# Alewife Park

Cambridge, Massachusetts

SUBMITTED TO **Cambridge Community Development Department**

The following is a point-by-point response matrix to comments contained within the 5.17.21 email from Swaathi Joseph. This information was sent via email on 5.27.21 to Swaathi Joseph and included the attached supporting information

AEGIS A 250  
DIMENSIONAL/CLEARANCE DRAWING

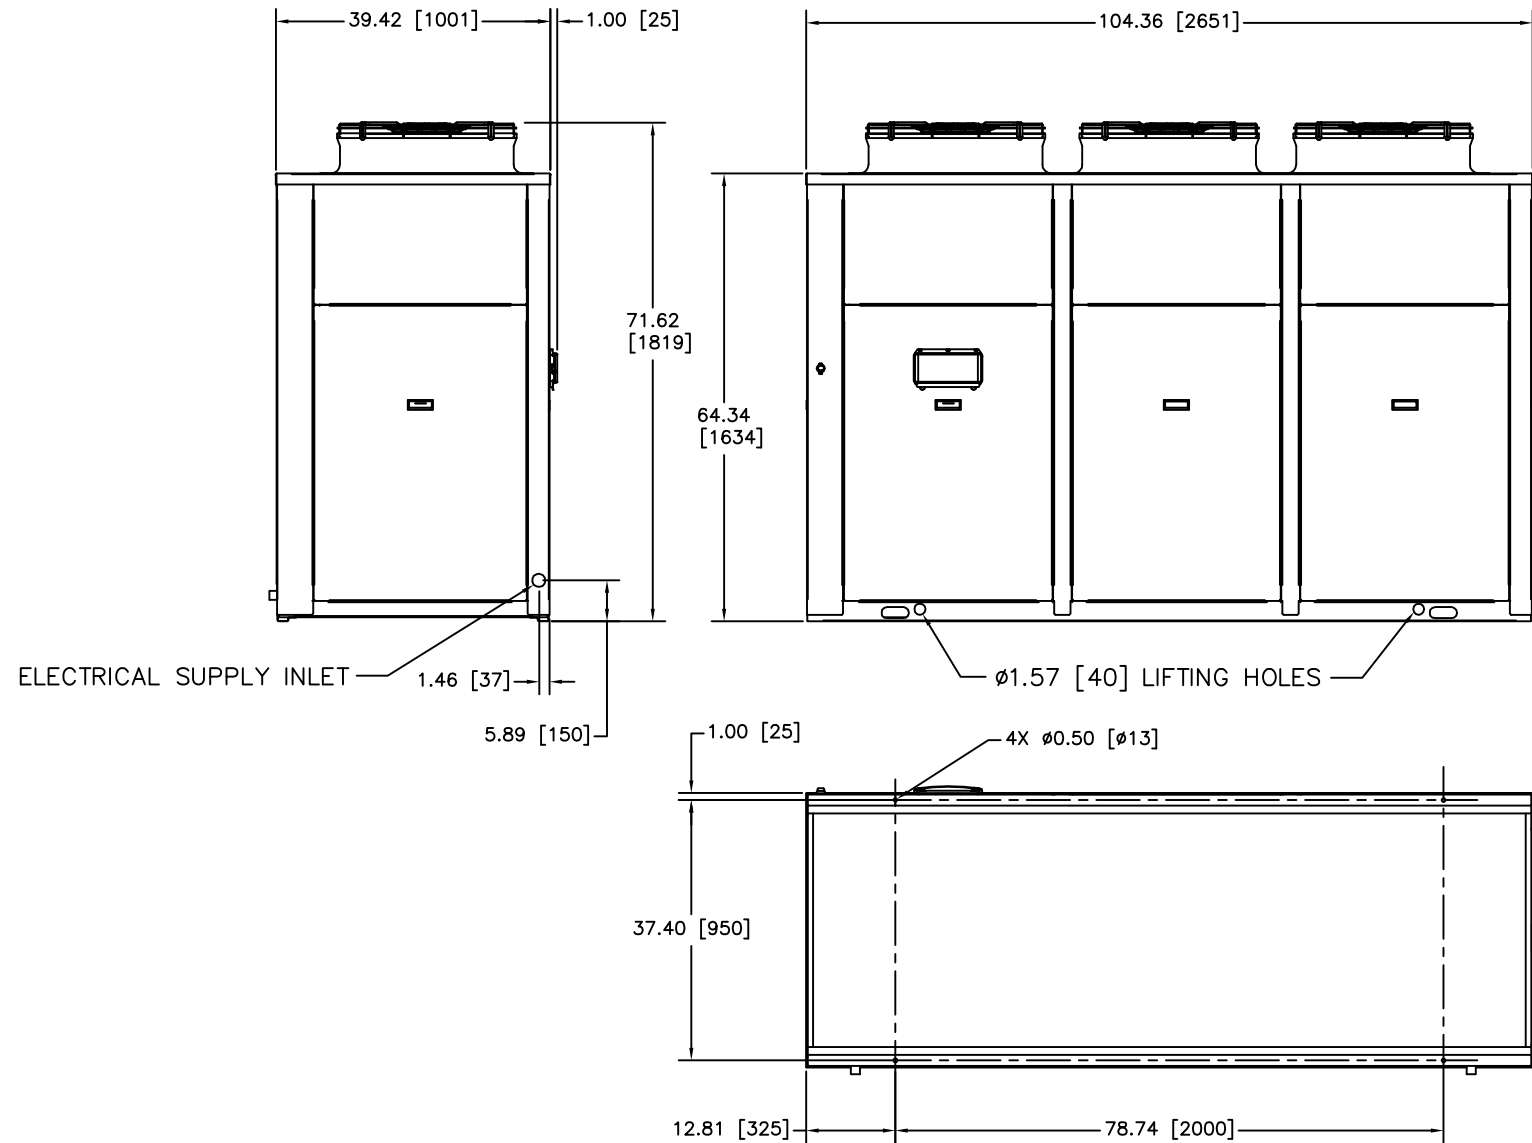
#	CDD comments (from 5.17.21 email from Swaathi Joseph)	Team Response
1	In the Net Zero Scenario narrative matrix, specifically related to a 100% heat-pump alternative transition process, staff appreciates the analysis provided explaining the cost implications of using the current technology of 100% heat-pump solutions. It would also be helpful to see the examples that served as a basis for this analysis (e.g., providing manufactures names (US or International technology companies).	Please see the attached cutsheet for the Multistack "400-Ton-Air-Cld_Chiller" as provided by RWS
2	For domestic hot water, also see the above bullet. It is our understanding that this energy source could also be part of that modular technology, including heat recovery. (again, please provide information on companies that their systems have been precluded due to cost.)	Please see the attached cutsheet for the Multistack "Domestic-heater_PVI-Aegis Air source 250" as provided by RWS

QTY = 1  
(base building only, future tenant would require 3 more)

**62 WHITTEMORE AVE.**  
 FLOOR PLANS: BUILDING 3 - LEVEL 3- MPH

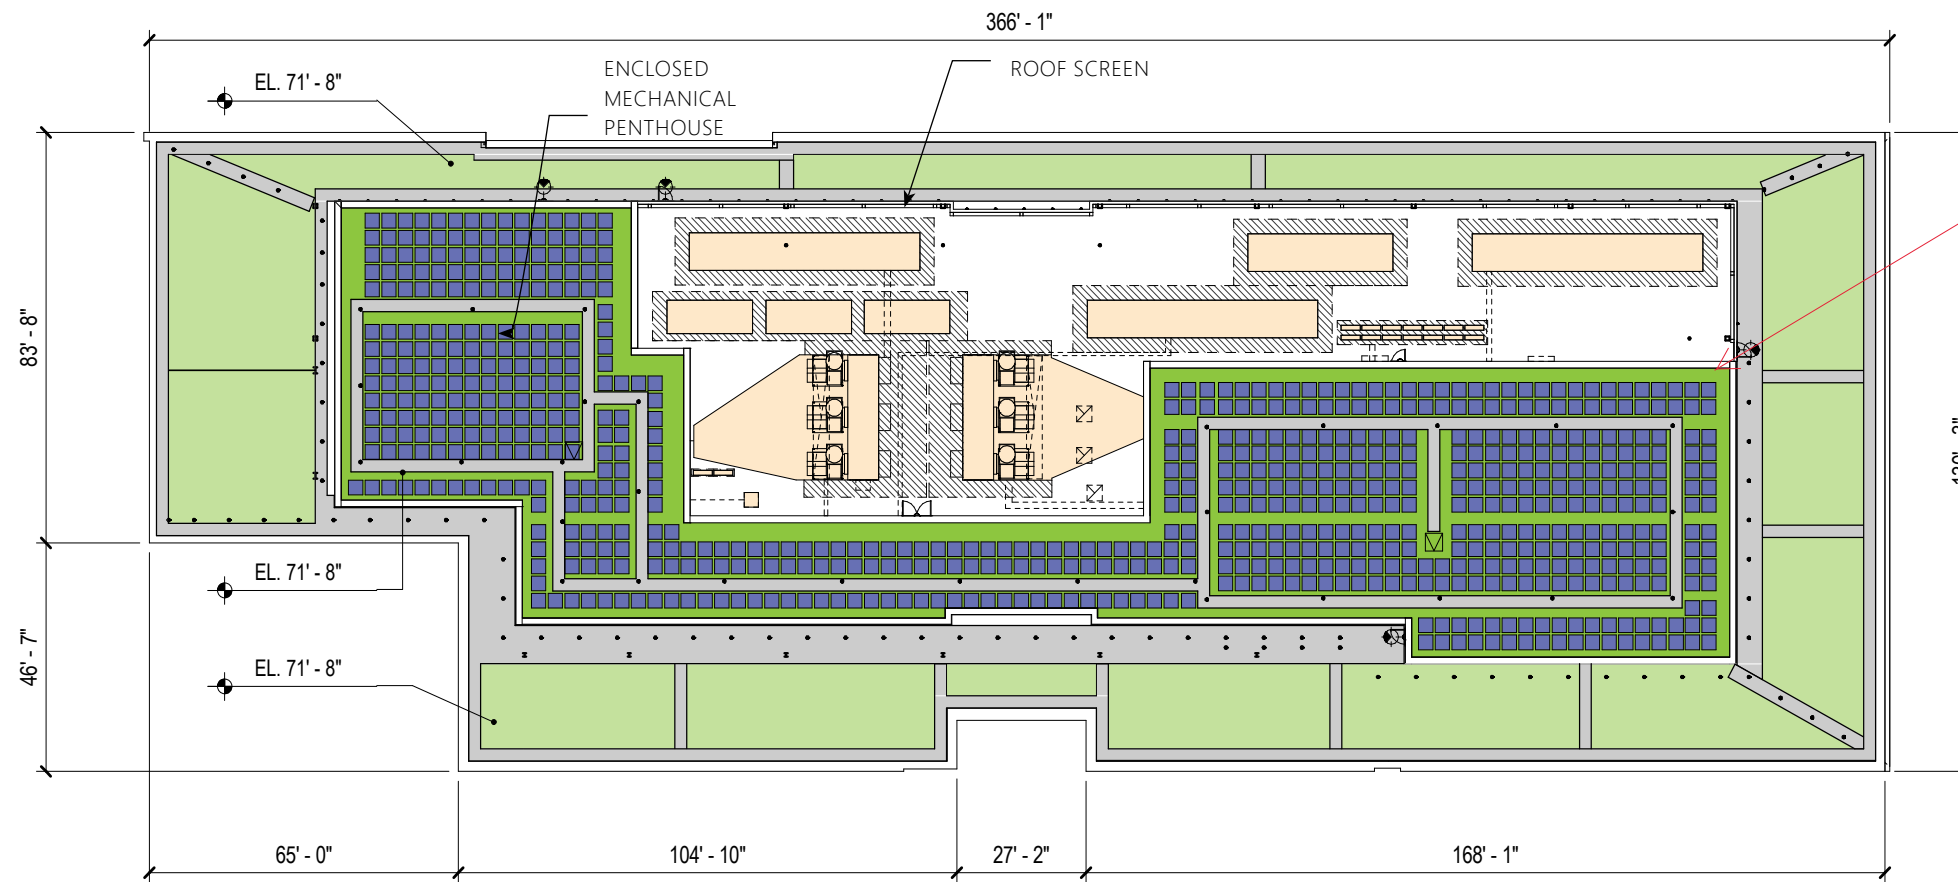
3	Provide an estimate as to what the projected power generated with the PV installations on buildings, surface lot east of building #3 and parking structure.	Please see the current working scheme for biosolar on the mechanical rooftops of buildings 3, 4 & 5. Refer to the attached "36-64 Whittemore_MPH Plans" & "36-64 Whittemore_Concept Surface lot PV" plan Rough Preliminary estimates: Bldg 3: 183kWp - 215,000 kWh/yr Bldg 4: 132kWp - 155,000 kWh/yr Bldg 5: 139kWp - 165,000 kWh/yr Surface lot: 200kWp - 240,000 kWh/yr
4	Considering the number of existing buildings to remain in the project campus, what are the strategies to address green building and sustainability for these buildings? Has the team considered LEED EBOM for existing buildings renovations and improvements?	For existing buildings that are not slated for redevelopment within 1-2 years, we plan to achieve Energy Star Certification with a score of 75 or higher, and evaluate the feasibility of targeting LEED EBOM Certification. Per IQHQ's Design and Construction Guidelines, all major renovations are required to achieve LEED Gold BD+C Core & Shell Gold Certification.

10,320SF of Biosolar area  
 approximately 132kWp system  
 ~155,000kWh/yr
